**RE: *Penske Truck Leasing (#1605457)  
Pre-Application Meeting held February 17, 2022***

Thank you for the comments on March 3, 2022, for the above-mentioned project. In an effort to address your comments concisely and simplify your review of the Site Plan package, we have summarized your comments and our responses below.

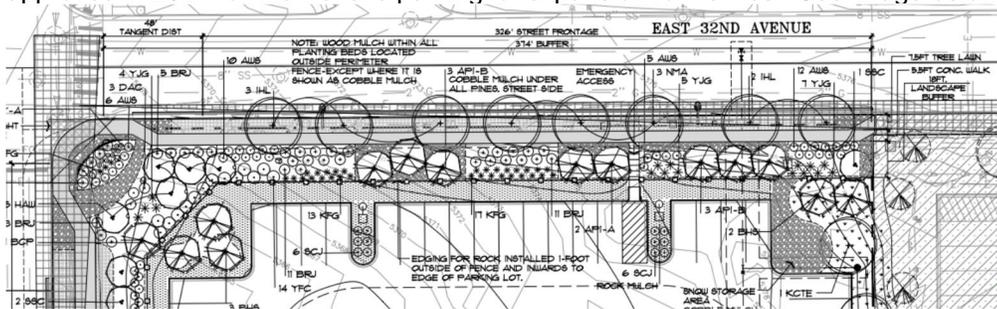
Include sight distance triangles per the Roadway Design and Construction Specifications document. All landscaping within the designated triangles shall not exceed 26" in height as measured from the roadway surface.

- Response: Sight distance triangles have been provide on the landscape plans.
